RESOLUTION NO. 2019-

Accepting Bid for the repair and improvement of the Human Services parking lot at the Lueder Haus building

Lueder Haus Parking Lot

LUEDER HAUS
PARKING LOT REBUILD

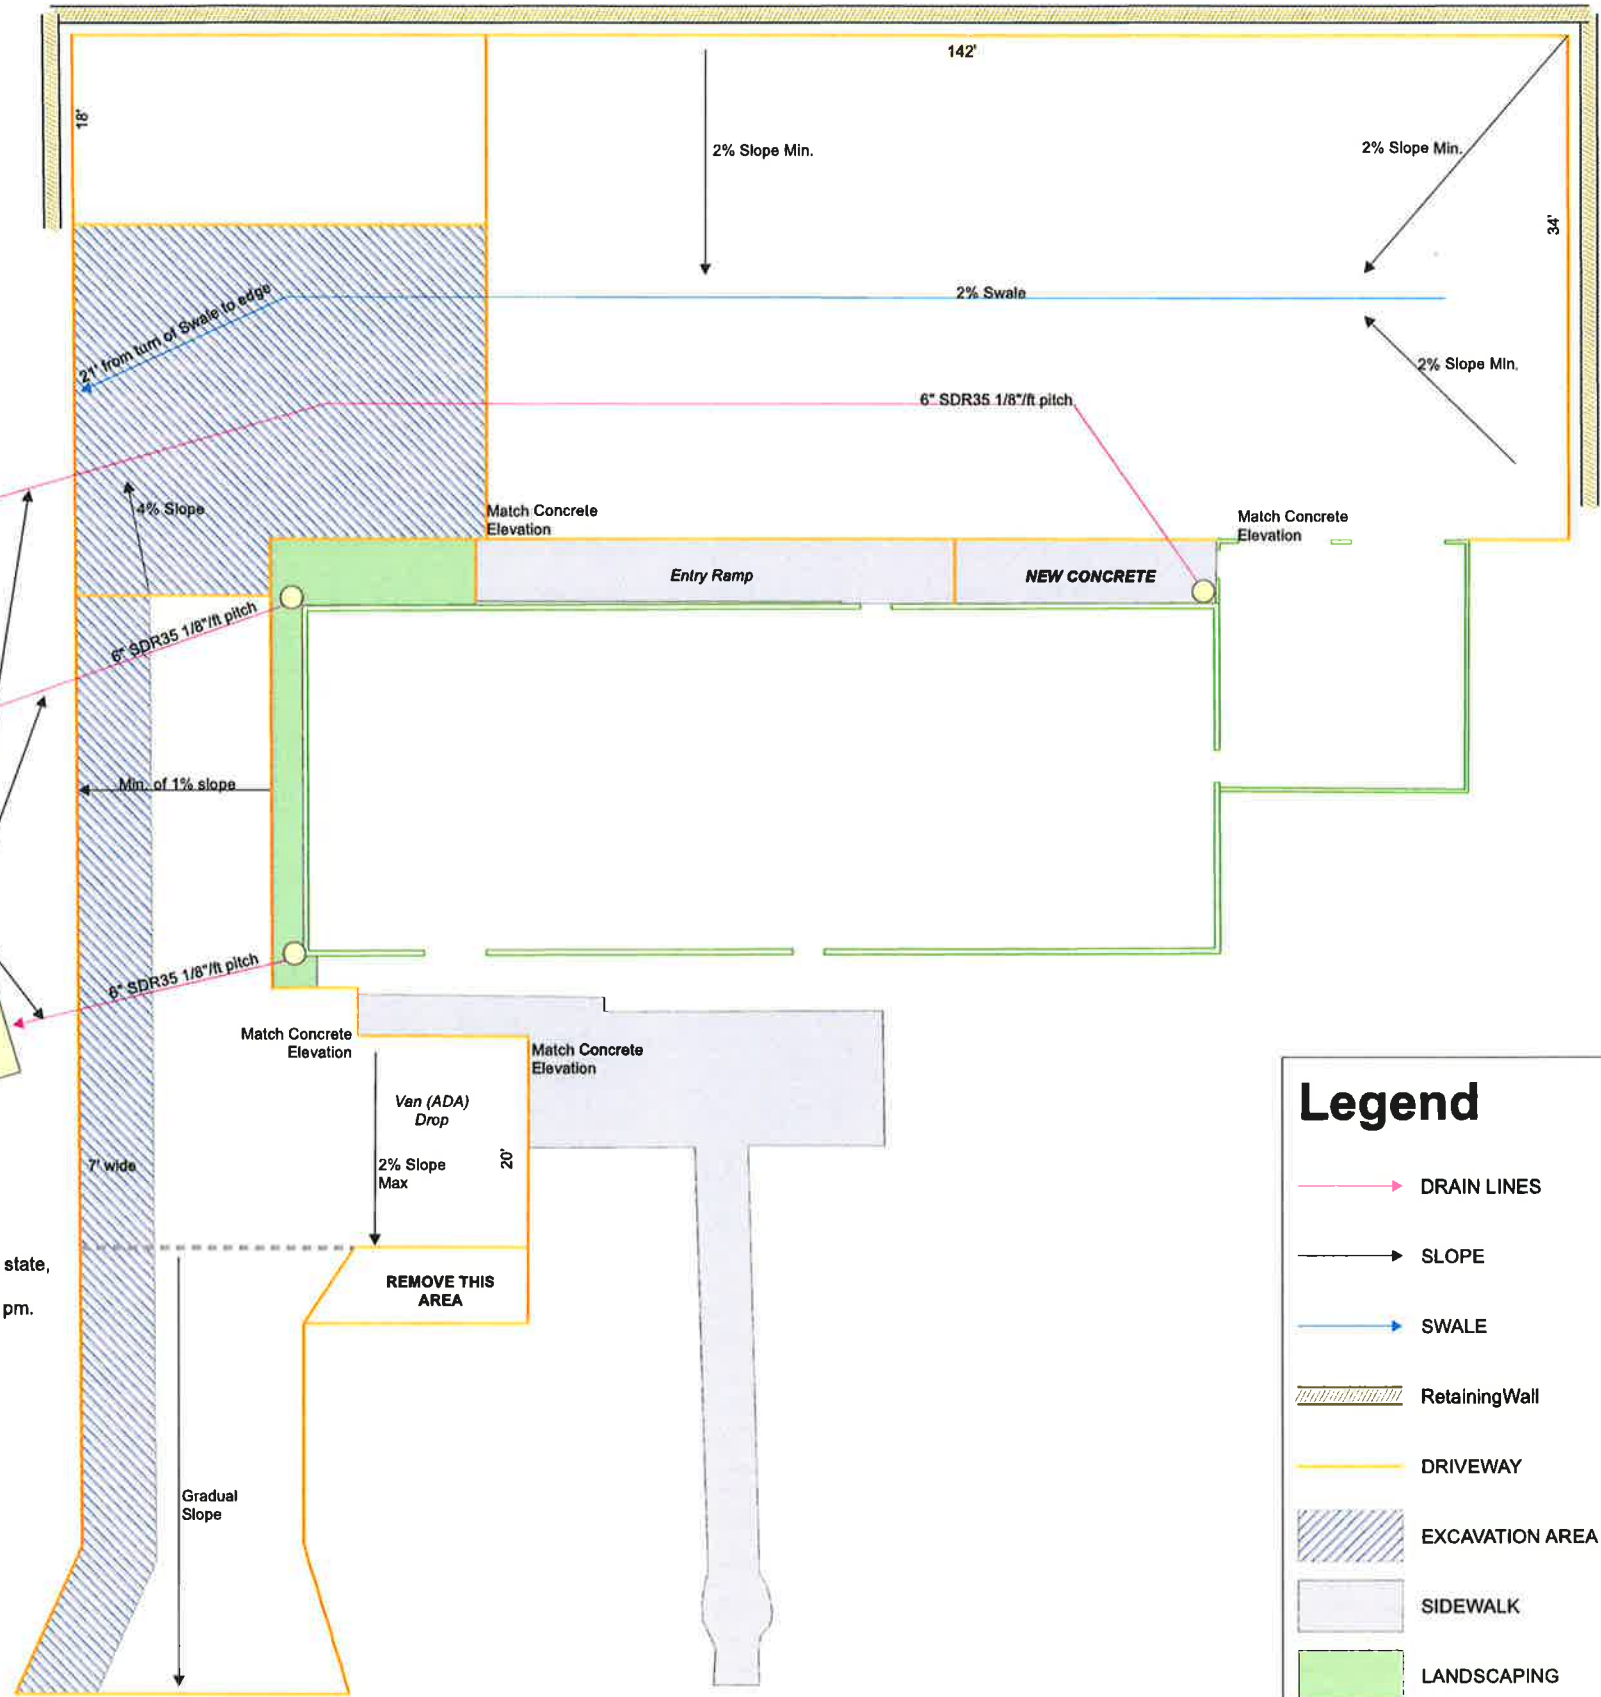
1. Please verify the tonnage of excavation base material and cost to complete, for the area noted on the plan as "Excavation Area". This amount should include removal and install of new material.
2. Please verify the asphalt layers specified in estimate if different than specified in plans and cost differences associated.
3. Please verify if your estimate includes paint markings for the ADA Van drop off and stall striping for the upper parking area. Please note cost for this portion of the project.

1. Please verify the tonnage of excavation base material and cost to complete, for the area noted on the plan as "Excavation Area". This amount should include removal and install of new material.
2. Please verify the asphalt layers specified in estimate if different than specified in plans and cost differences associated.
3. Please verify if your estimate includes paint markings for the ADA Van drop off and stall striping for the upper parking area. Please note cost for this portion of the project.

- 1.) 17" undercut is part of the bid. 14" of rock is part of the undercut, also part of the bid.
2. 1-1/2" 19mm commercial grade mix.
1-1/2" 12.5mm commercial grade mix
3. Striping is also part of the bid. Standard Paint.

1. About 165 tons needed to rebase excavation area which is approximately 2,008 SF. That number is tied into my grading so I don't want to break that cost out. If your other contractor just adds this in to his proposal we should be apples to apples.
2. There would be a credit of \$375 if we use the 19mm binder mix instead of the 12.5mm binder mix. This is not recommended because the aggregate in the 19mm is too large for a 1.5" binder course lift of asphalt. You won't get proper compaction.
3. My quote includes striping. Value of striping is \$250.
